ZBA MEETING PACKET

02/09/22

Committee/Board/s	Zoning Board of Appeals
Day, Date, and Time	Thursday, February 09, 2023, at 1:00 PM
Location / Address	4 Fairgrounds Road, Nantucket, MA 02554 **PSF COMMUNITY ROOM & REMOTE PARTICIPATION VIA ZOOM WEBINAR**
Signature of Chair or Authorized Person	Leslie Woodson Snell, Deputy Director of Planning and Zoning Administrator
WARNING:	**IF THERE IS NOT A QUORUM OF MEMBERS OR IF THE MEETING POSTING IS NOT IN COMPLIANCE WITH THE OPEN MEETING LAW, NO DELIBERATIONS MAY TAKE PLACE-BUT THE MEMBERS MAY APPEAR AND ANNOUNCE A NEW SCHEDULE.**

37-21 Kristina & Nicholas Amendolare **8 Bank Street** **Williams**

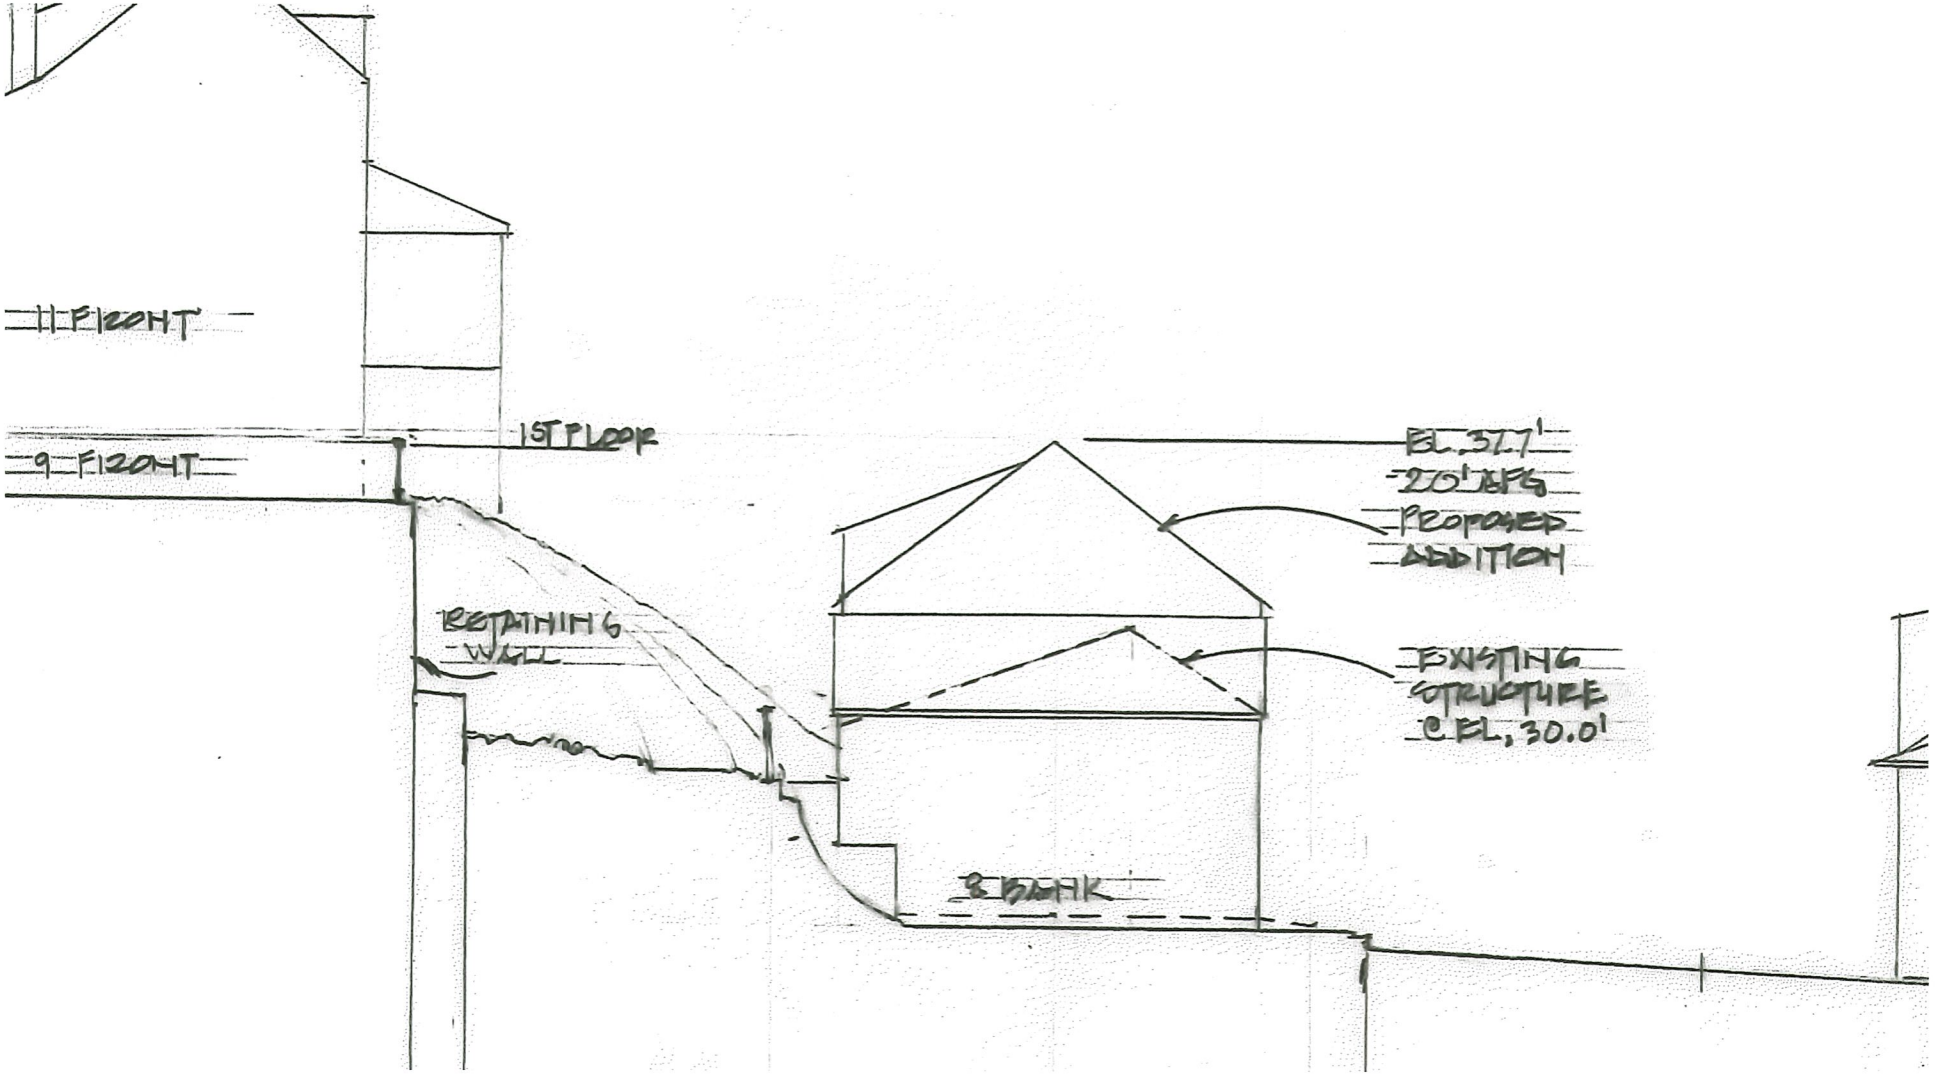
CHANGE HEIGHT FROM EL 30 TO EL 37.7 – 20 FT HEIGHT AS HDC APPROVED

FIGURE 2 – PROPOSED CONSTRUCTION

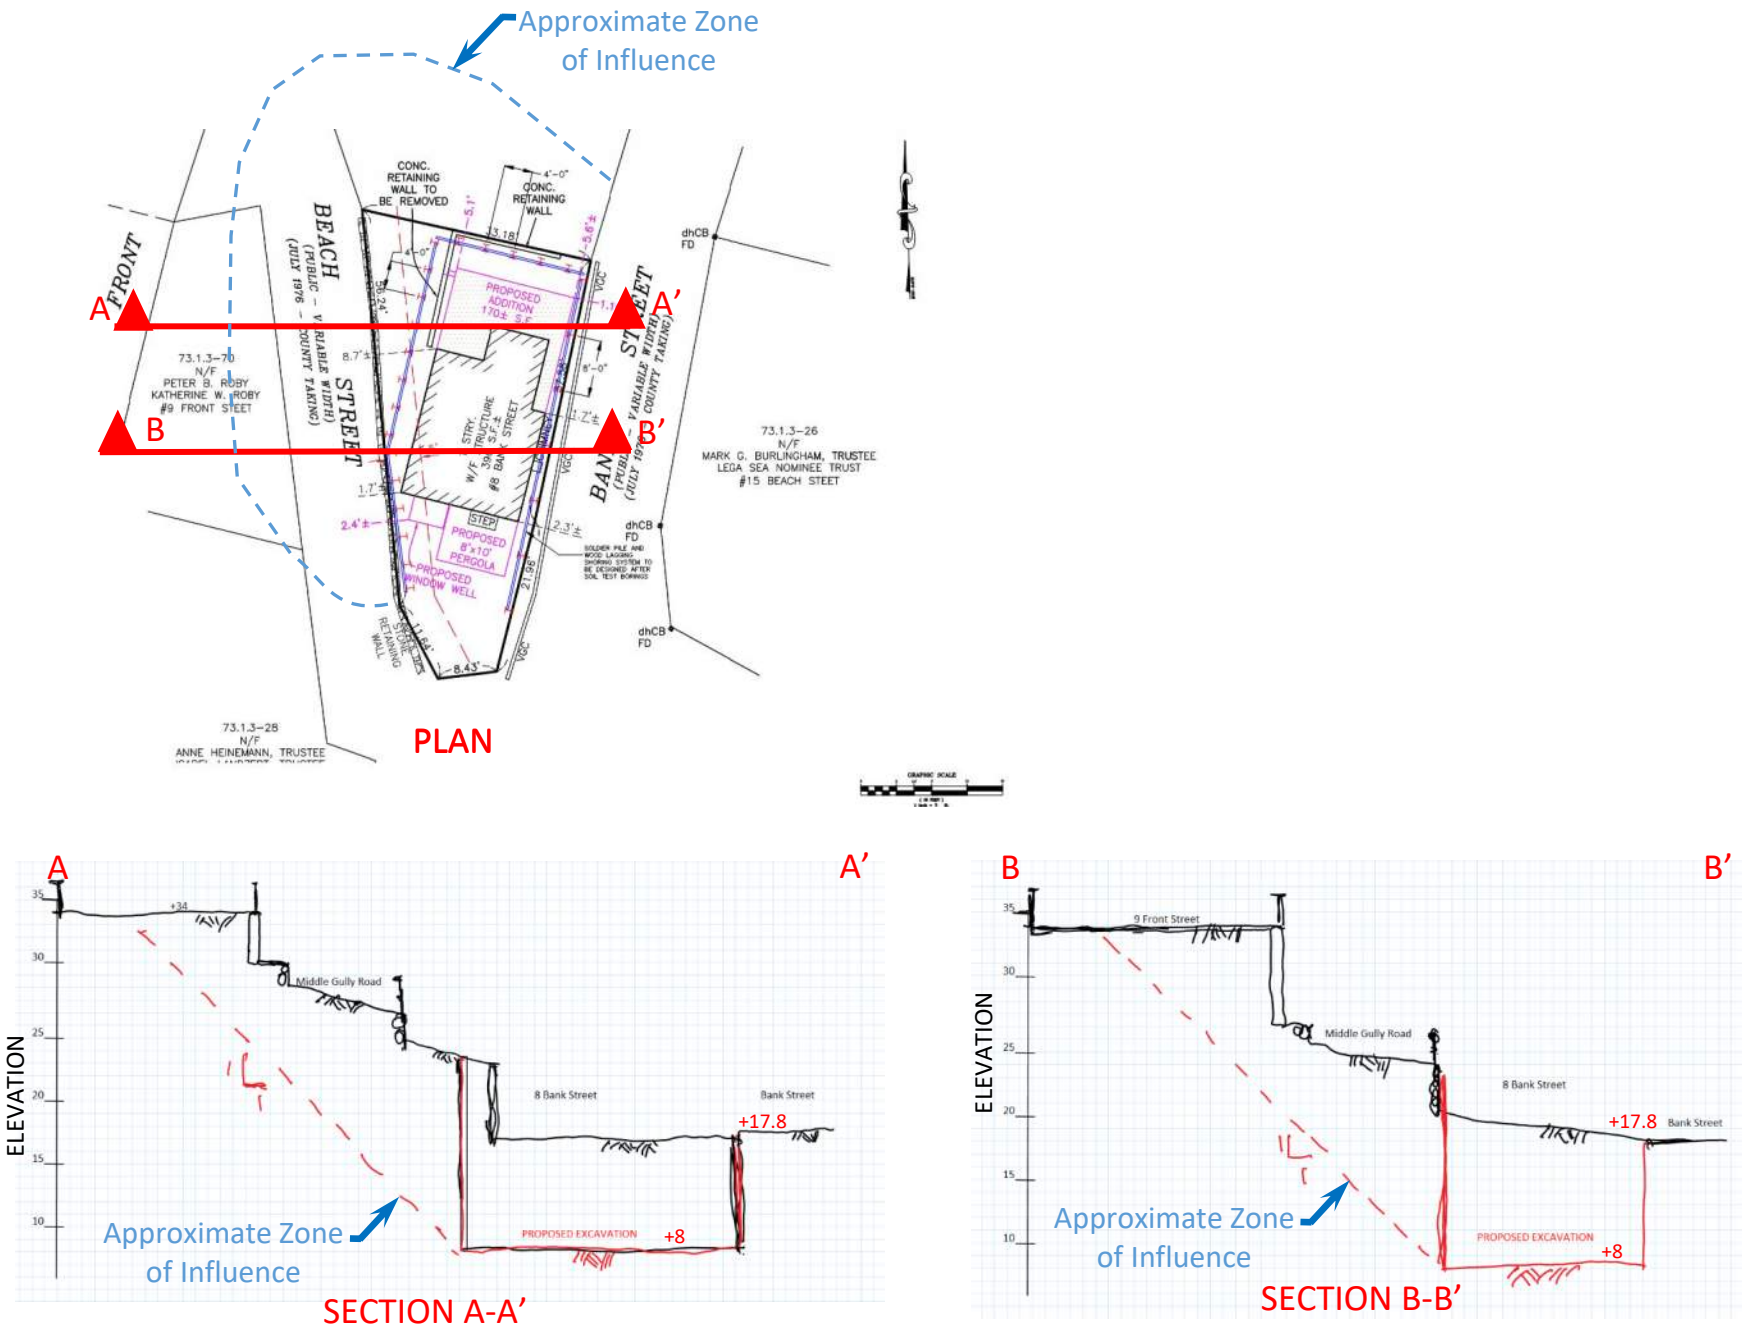
The proposed construction requires a deep excavation to a depth of more than 17 feet immediately below Middle Gully Road and the nearby retaining wall supporting 9 Front Street. Furthermore, the retained ground slopes up to a higher elevation, resulting in increased lateral earth pressures on the SOE system as shown in cross-sections A-A' and B-B' in Figure 2.

In general, even a well-designed and supported excavation has potential to impact ground within a 1:1 (horizontal to vertical) zone of influence from the bottom of the excavation. As illustrated in plan and section on Figure 2, all of Middle Gully Road and most of 9 Front Street are within the potential 1:1 zone of influence of the deep excavation required for basement construction at 8 Bank Street. The structure at 9 Broadway is generally beyond the potential zone of direct influence. As a result, the proposed deep excavation could cause ground loss and instability of the retained ground in a number of ways including but not limited to:

FIGURE 2 – PROPOSED CONSTRUCTION

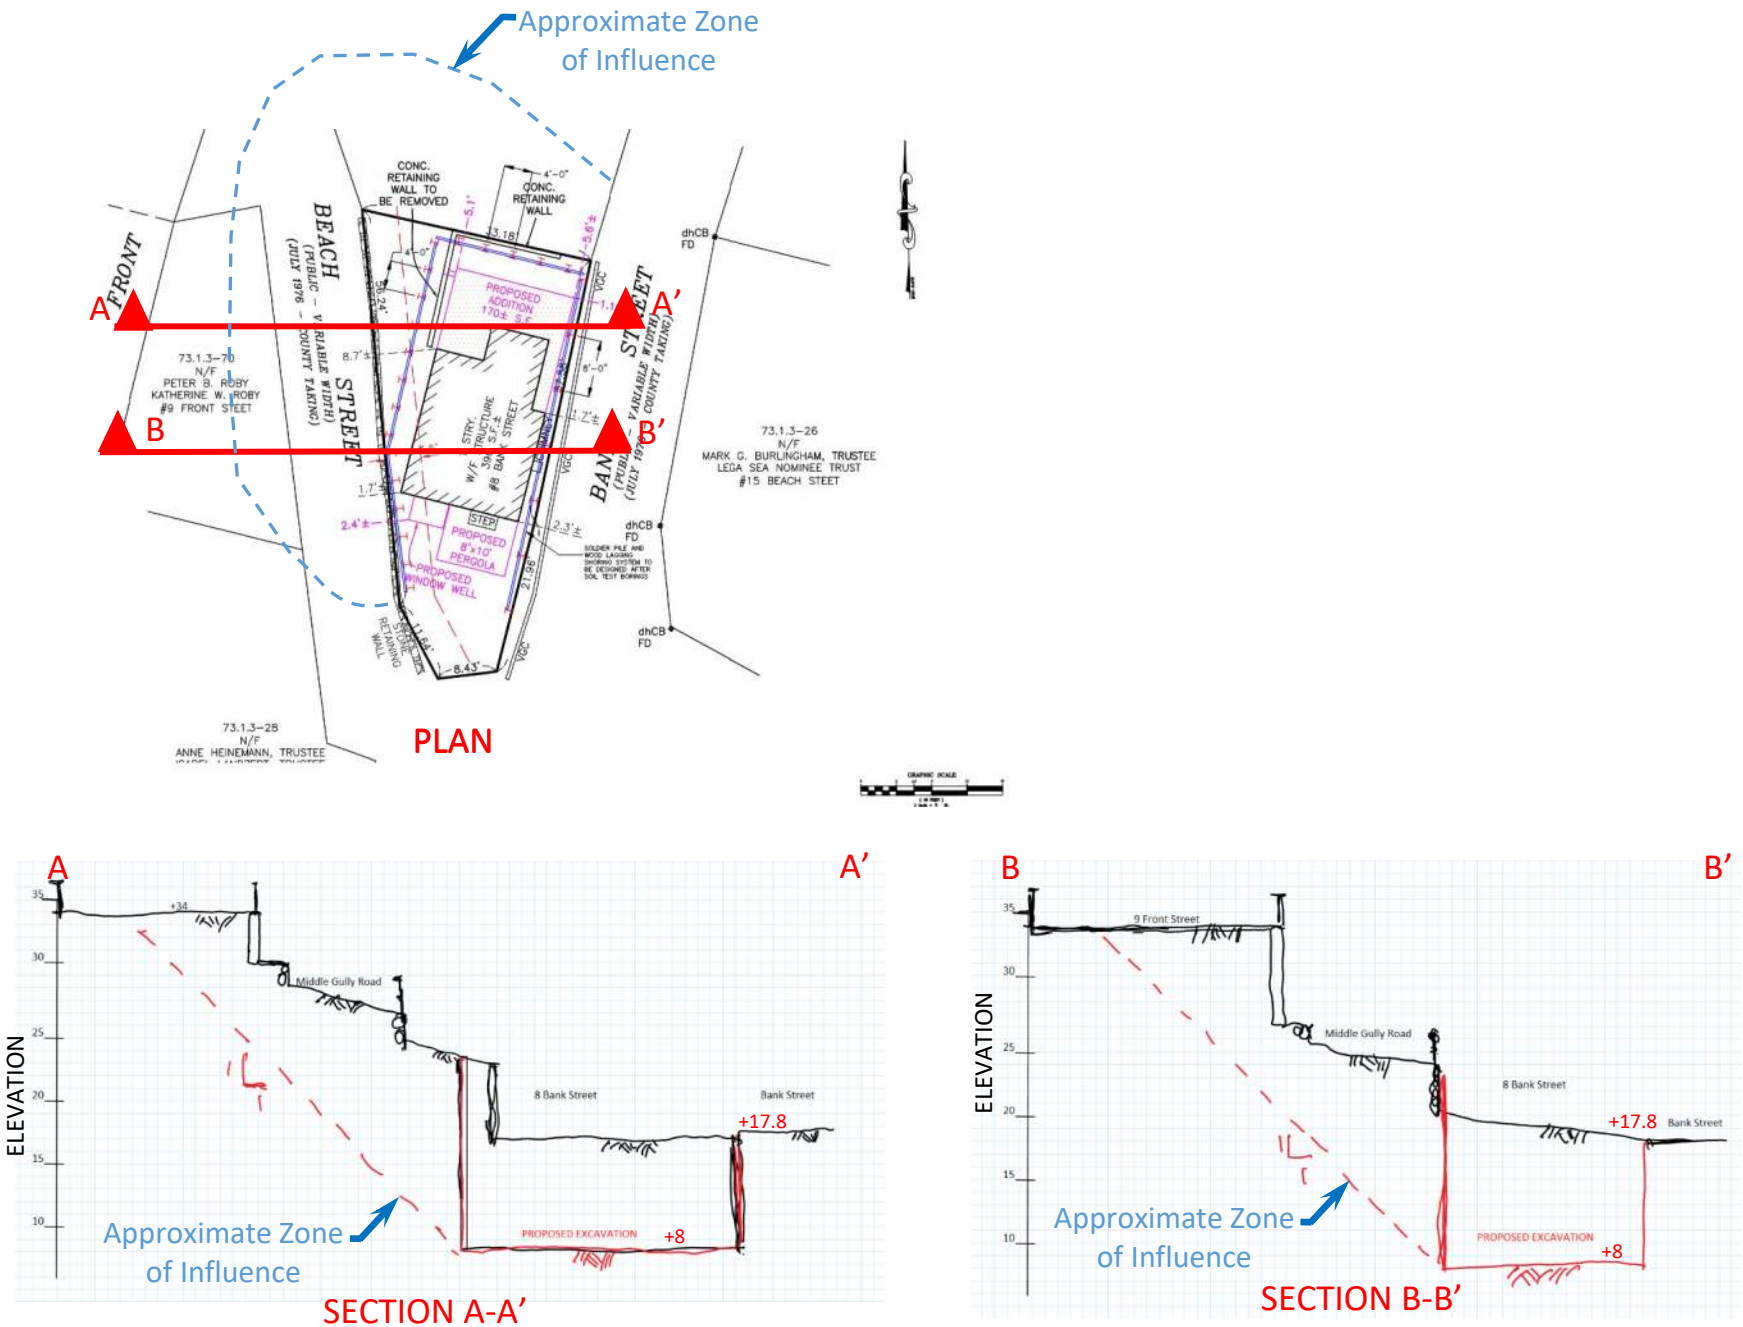
The proposed construction requires a deep excavation to a depth of more than 17 feet immediately below Middle Gully Road and the nearby retaining wall supporting 9 Front Street. Furthermore, the retained ground slopes up to a higher elevation, resulting in increased lateral earth pressures on the SOE system as shown in cross-sections A-A' and B-B' in Figure 2.

In general, even a well-designed and supported excavation has potential to impact ground within a 1:1 (horizontal to vertical) zone of influence from the bottom of the excavation. As illustrated in plan and section on Figure 2, all of Middle Gully Road and most of 9 Front Street are within the potential 1:1 zone of influence of the deep excavation required for basement construction at 8 Bank Street. The structure at 9 Broadway is generally beyond the potential zone of direct influence. As a result, the proposed deep excavation could cause ground loss and instability of the retained ground in a number of ways including but not limited to:

FIGURE 2 – PROPOSED CONSTRUCTION

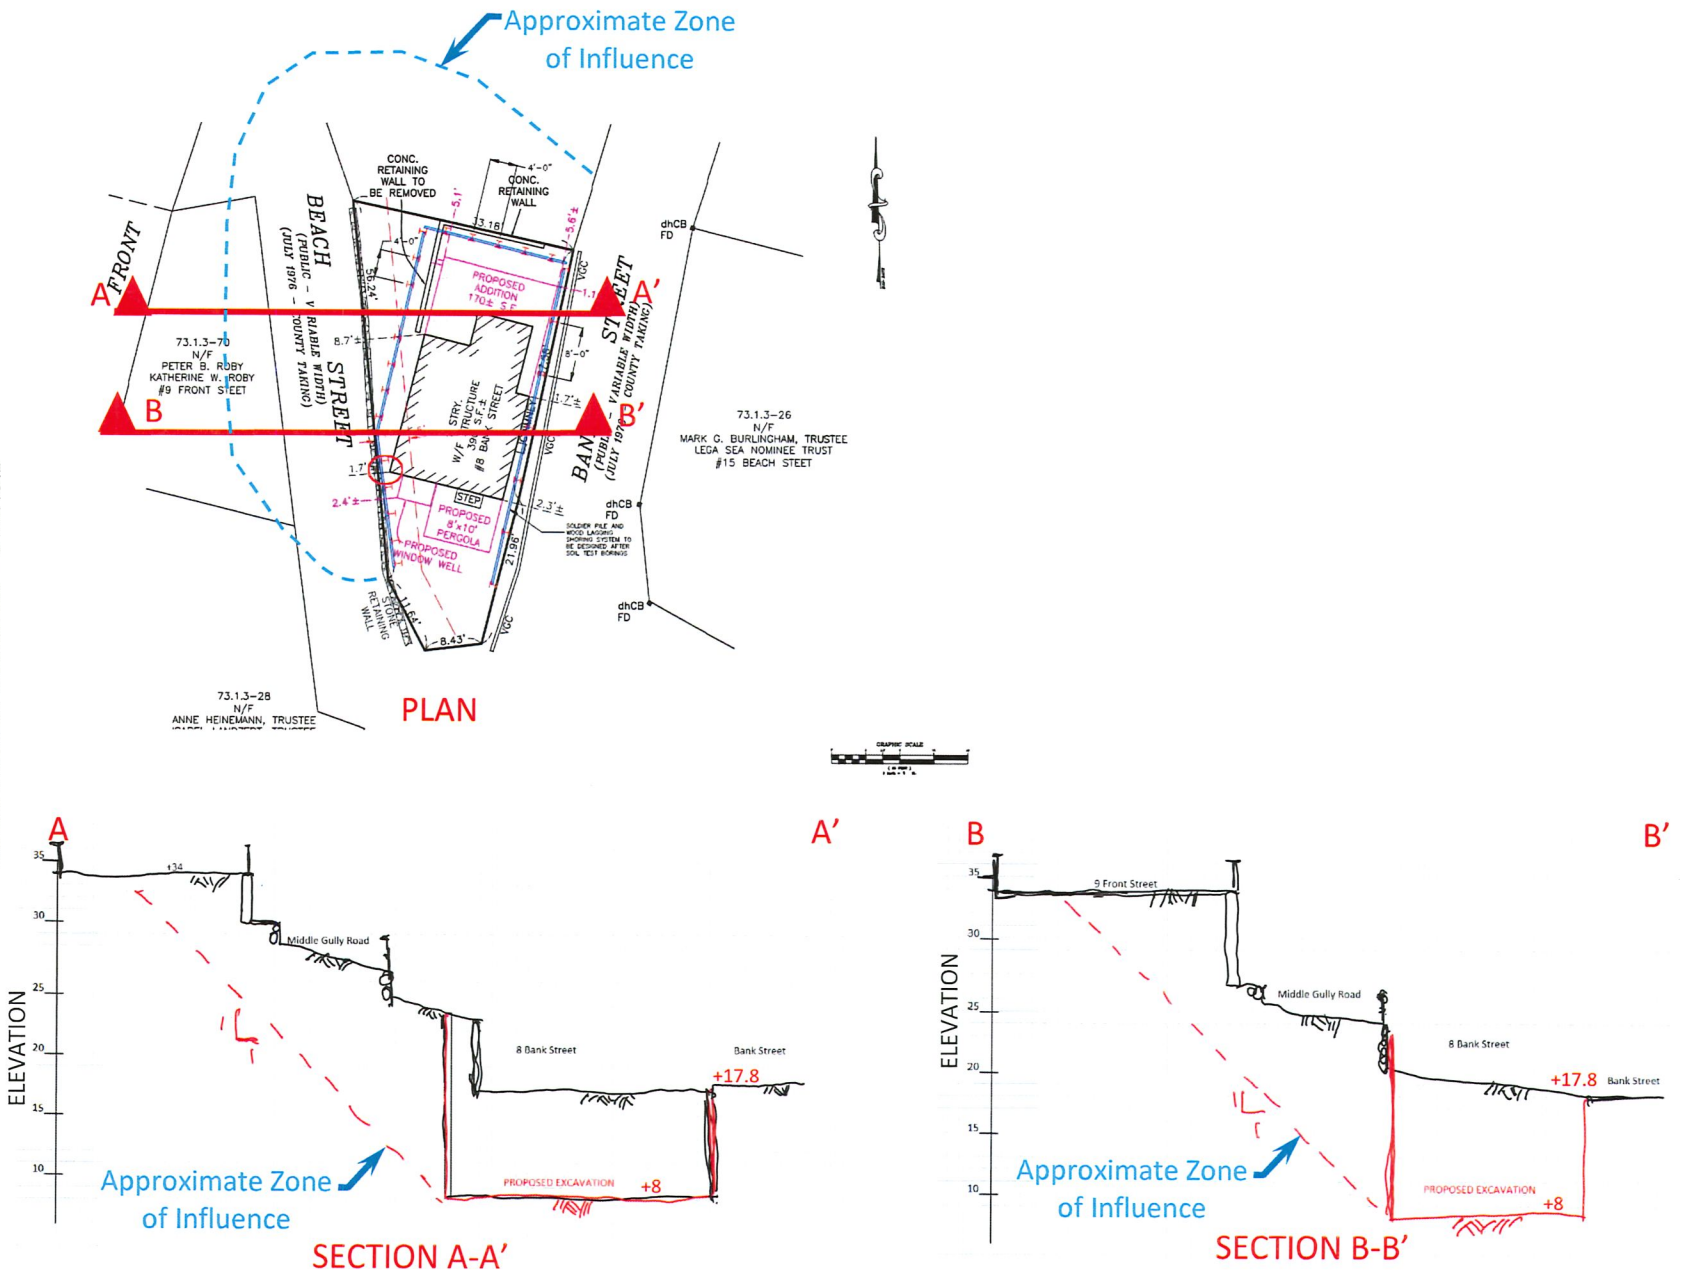
The proposed construction requires a deep excavation to a depth of more than 17 feet immediately below Middle Gully Road and the nearby retaining wall supporting 9 Front Street. Furthermore, the retained ground slopes up to a higher elevation, resulting in increased lateral earth pressures on the SOE system as shown in cross-sections A-A' and B-B' in Figure 2.

In general, even a well-designed and supported excavation has potential to impact ground within a 1:1 (horizontal to vertical) zone of influence from the bottom of the excavation. As illustrated in plan and section on Figure 2, all of Middle Gully Road and most of 9 Front Street are within the potential 1:1 zone of influence of the deep excavation required for basement construction at 8 Bank Street. The structure at 9 Broadway is generally beyond the potential zone of direct influence. As a result, the proposed deep excavation could cause ground loss and instability of the retained ground in a number of ways including but not limited to:
